March 11, 2015

On behalf of Green Meadow, LLC and Charah, Inc., HDR provides the enclosed Addendum 2 regarding the permit application entitled:

*Permit Application, Colon Mine Site, Structural Fill, Charah, Inc., Sanford, North Carolina.*  
Prepared for Charah, Inc. Prepared by HDR Inc. November 2014. DIN 22354.

The purpose of this addendum is to relate proposed enhancement to certain design and engineering aspects of the proposed project, specifically regarding the liner system groundwater separation, stormwater and leachate management systems, and the water quality monitoring plan. In addition this addendum clarifies that a minimum five foot groundwater separation buffer is maintained in the design. The following provides a brief summary of the sections and revisions in this addendum.

SHEET  
**00C-06**

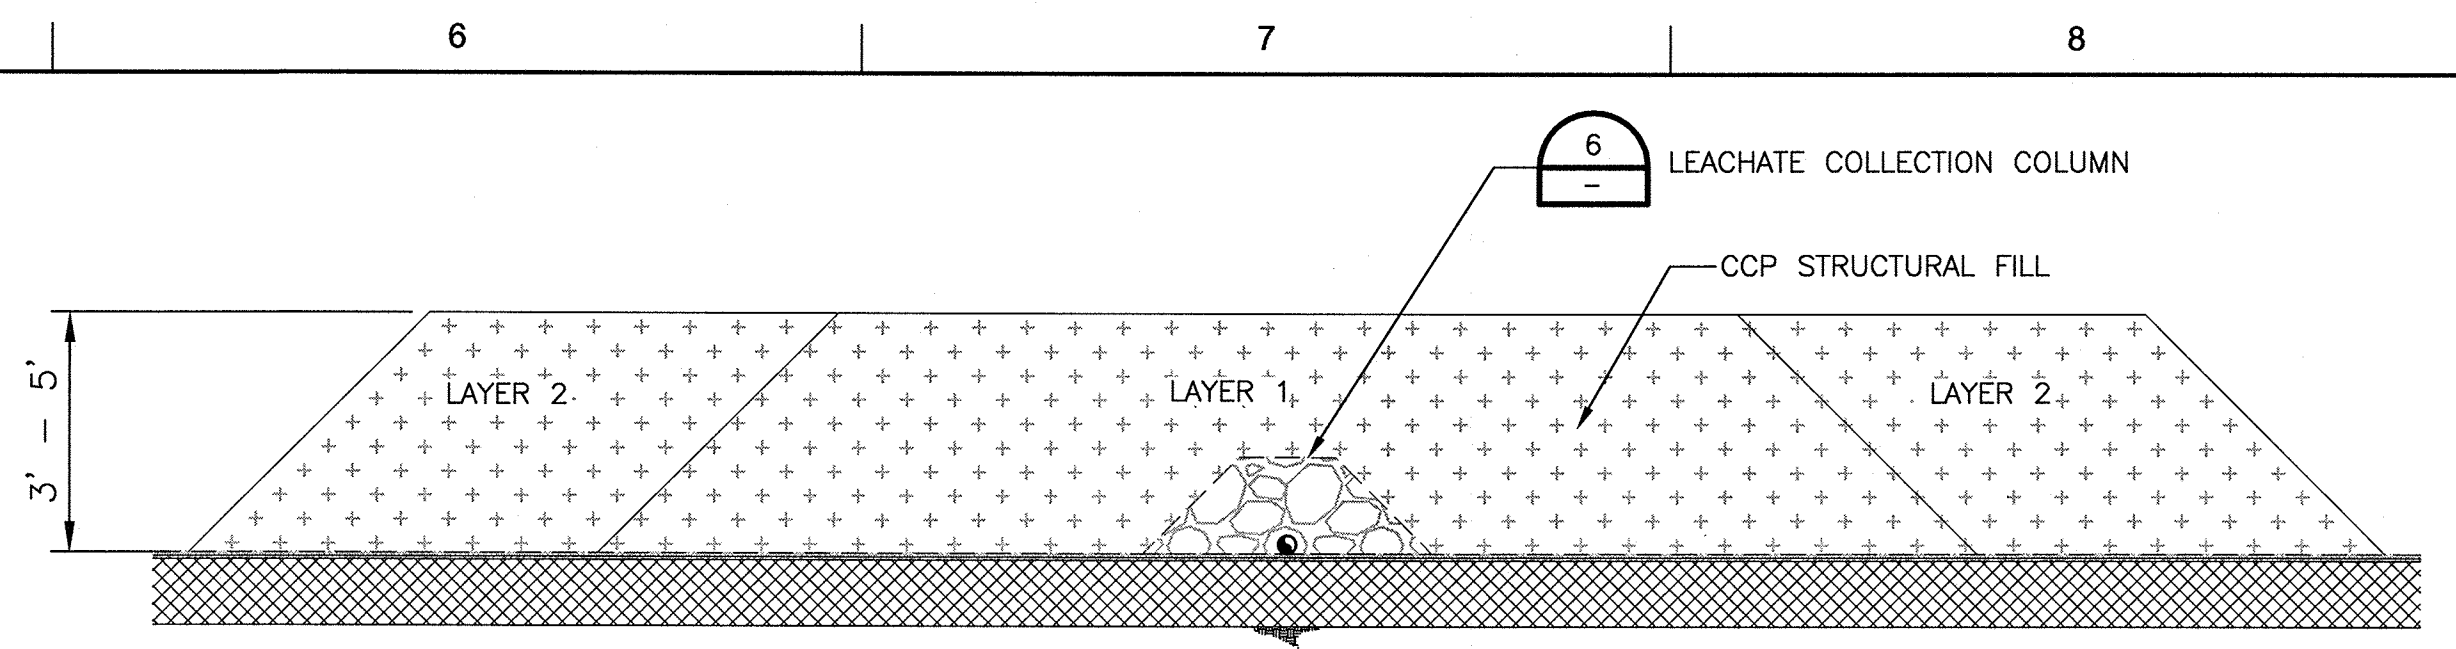
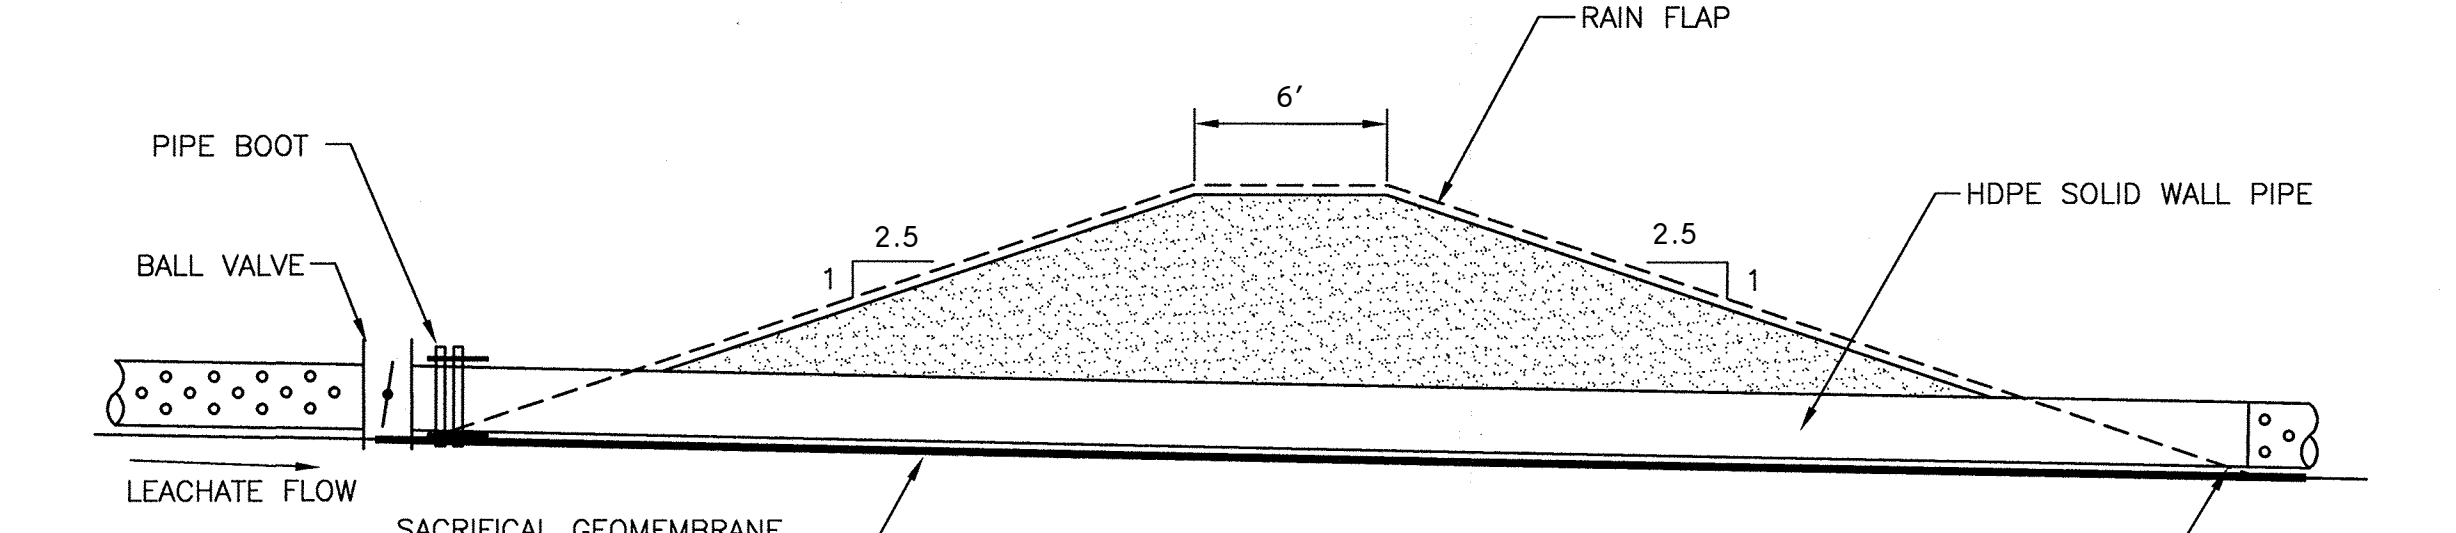
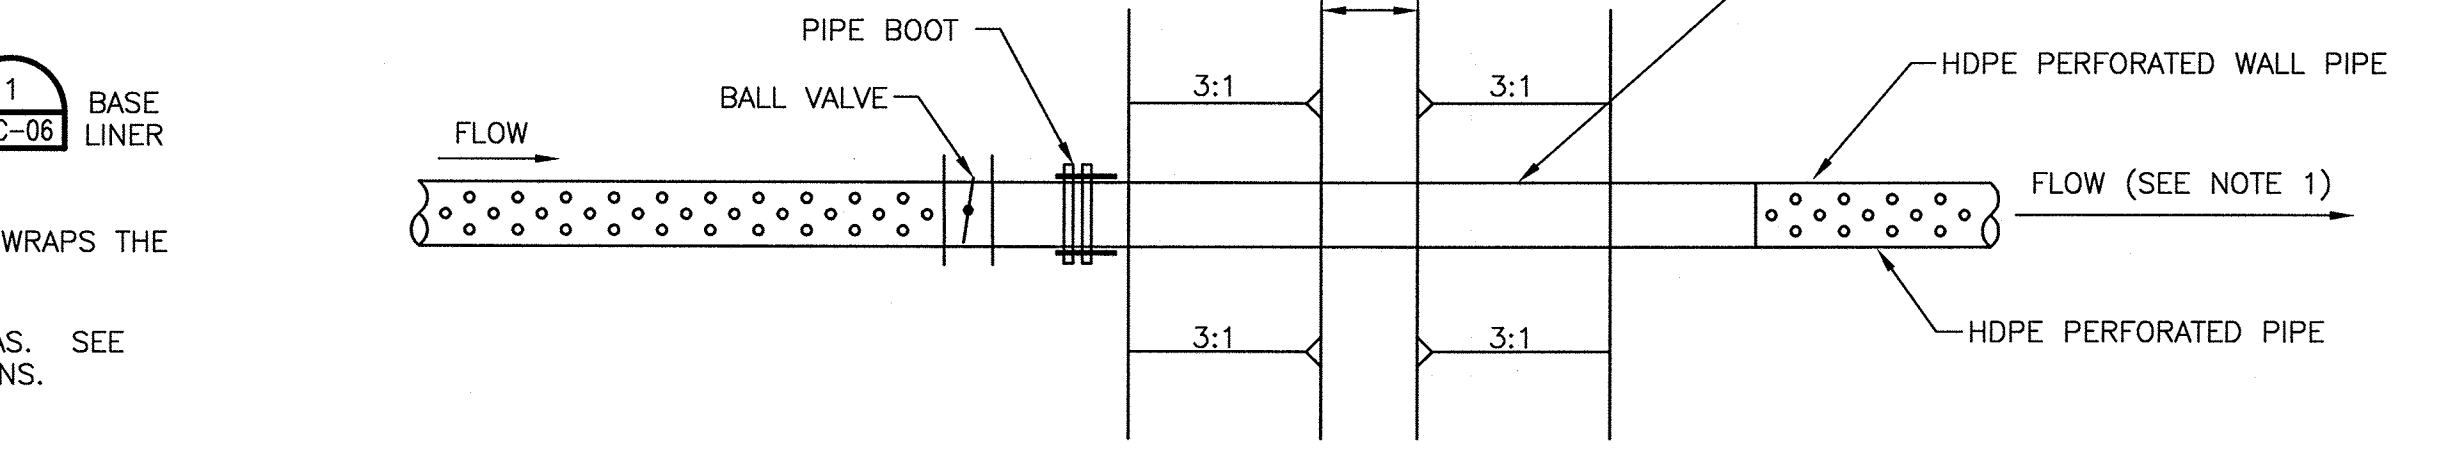
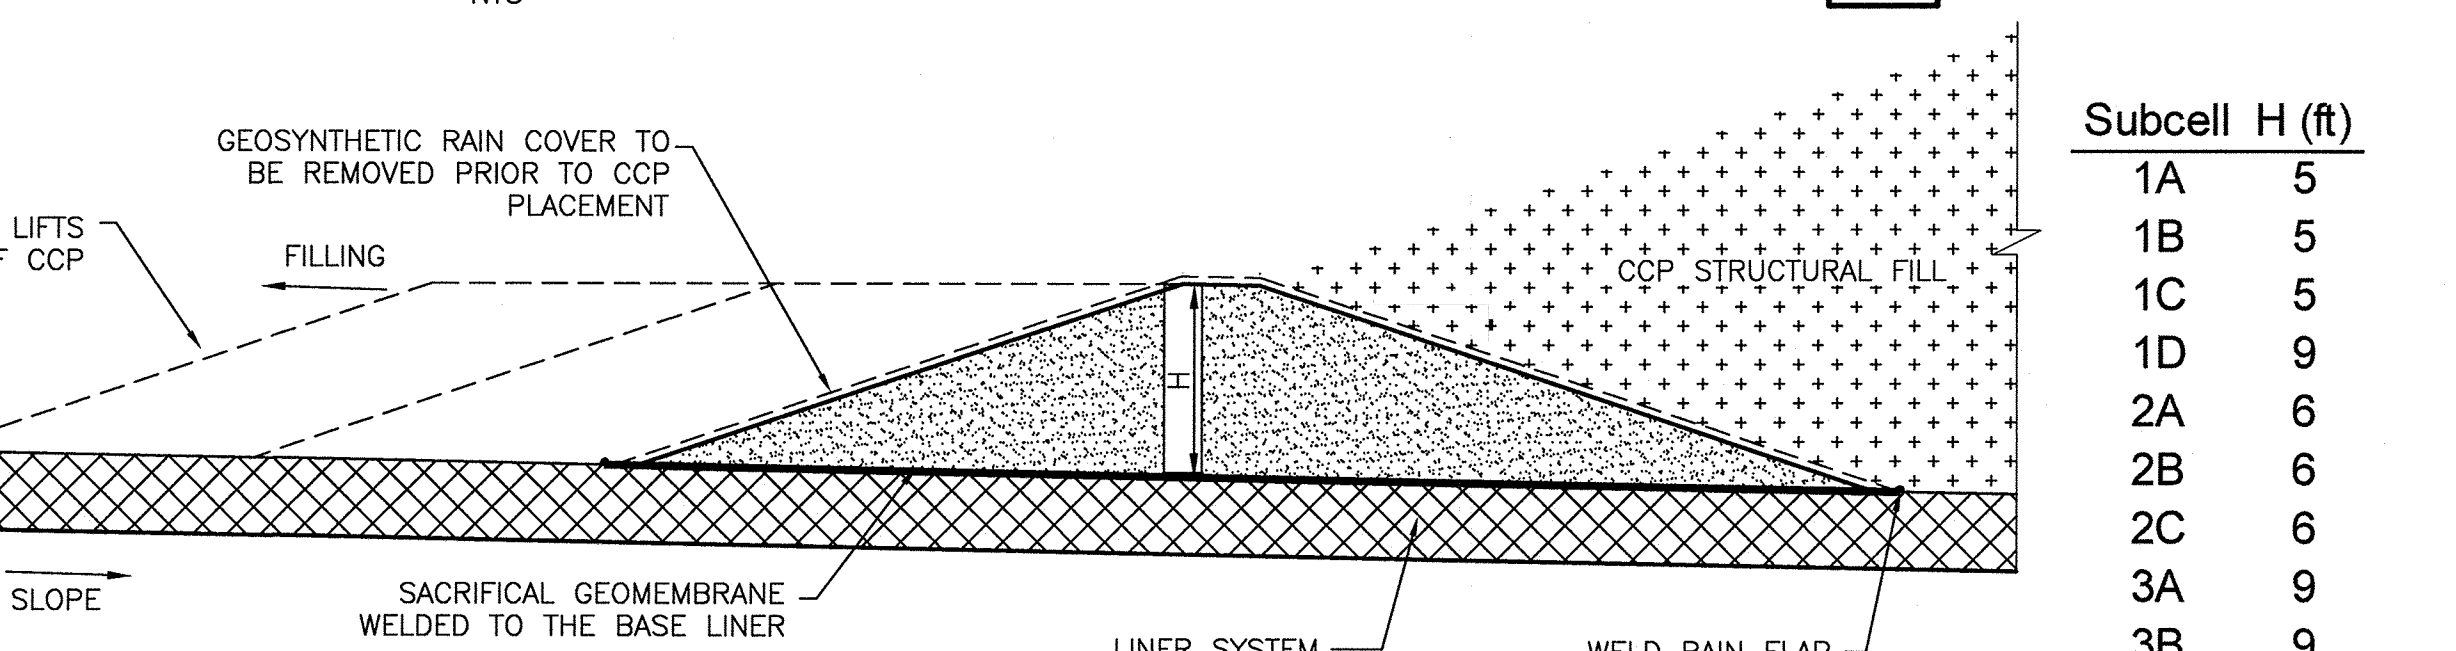
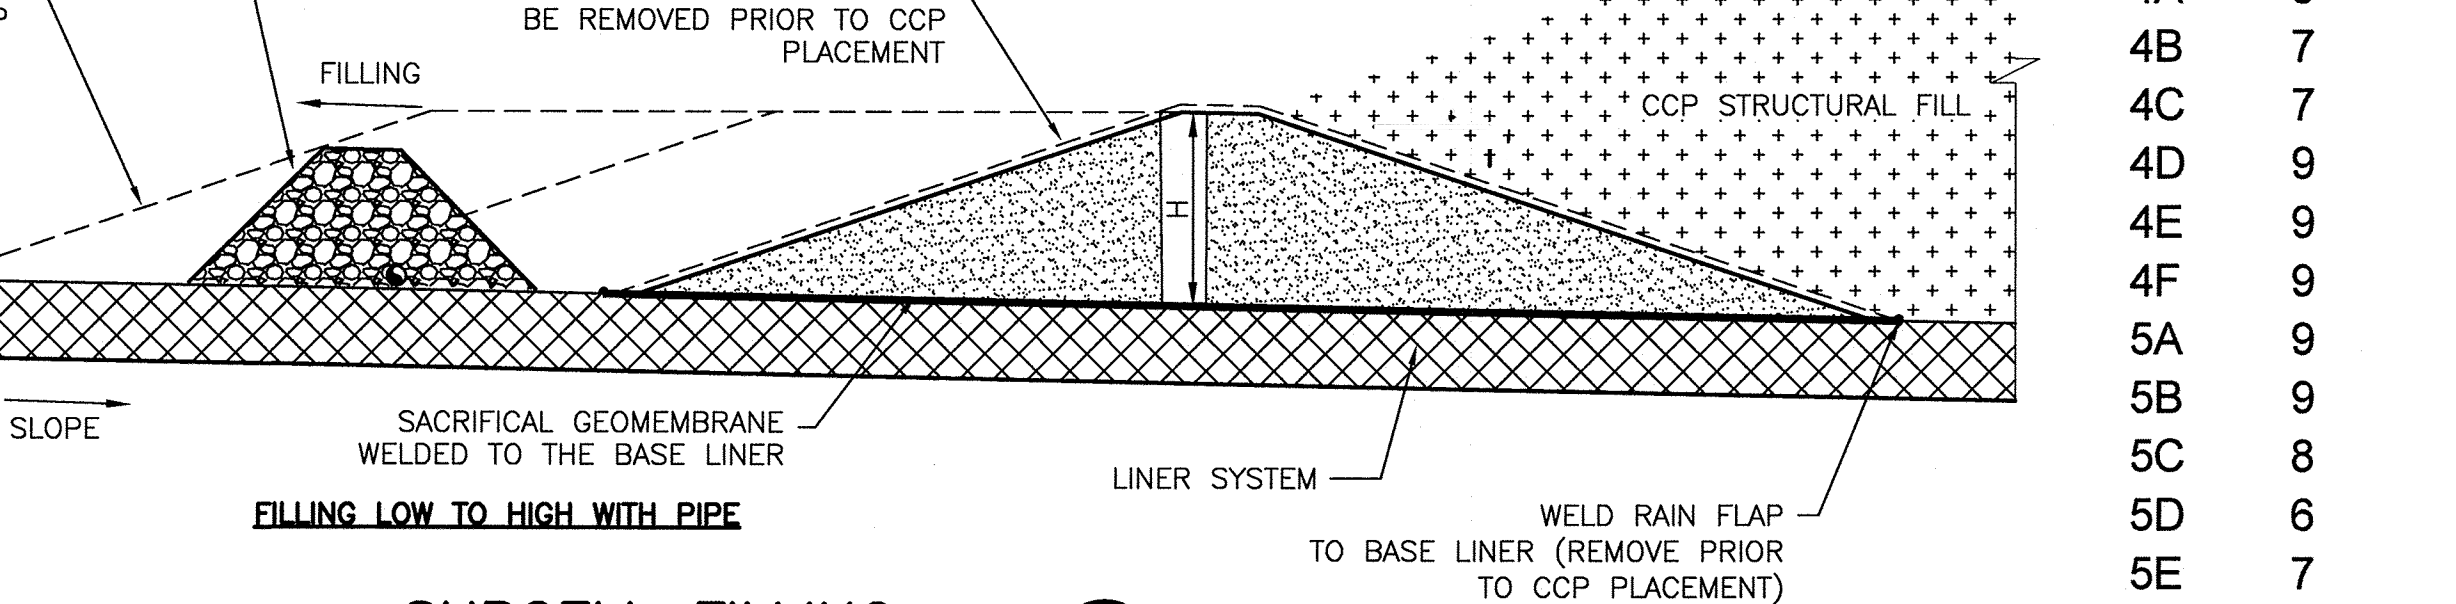
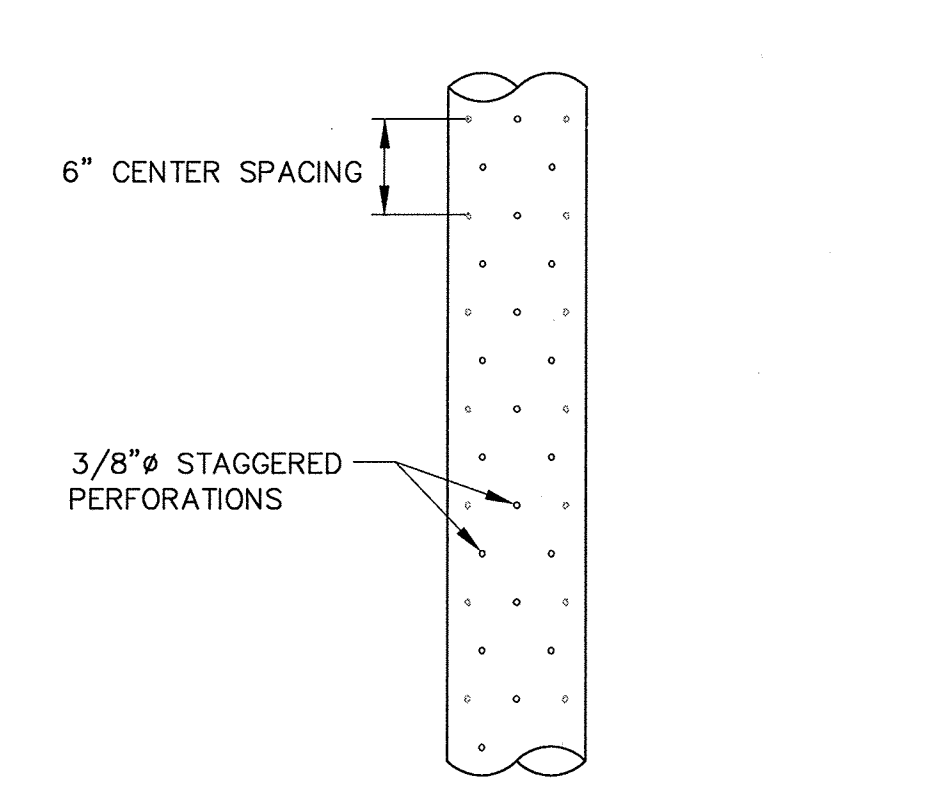
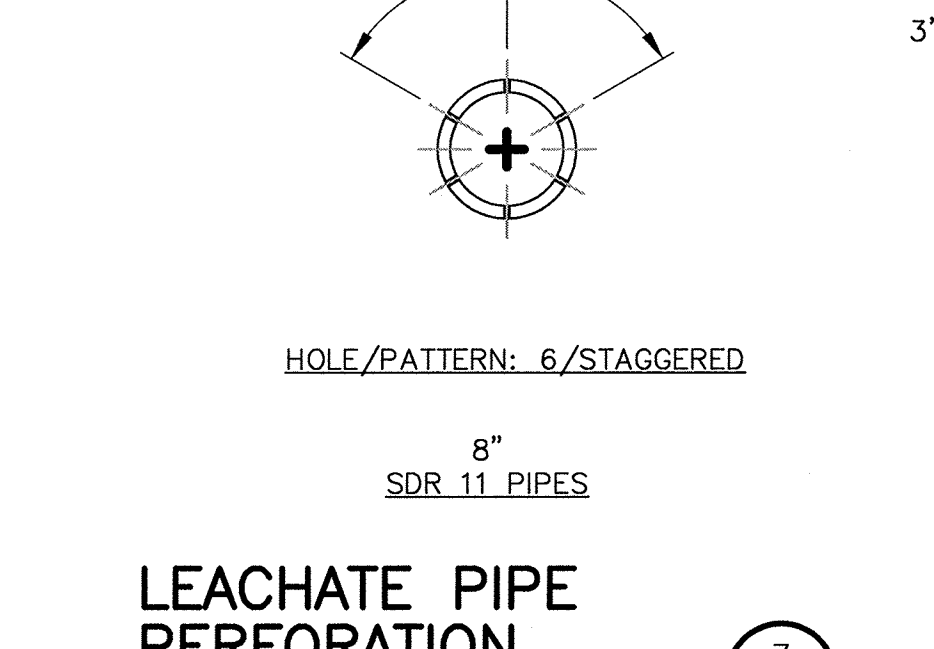
Drawing revisions include the reduction of subcell sized, inclusion of additional leachate collection piping, adjustment to associated drawing details, and modification to erosion control drawings and details to accommodate the larger design storm.
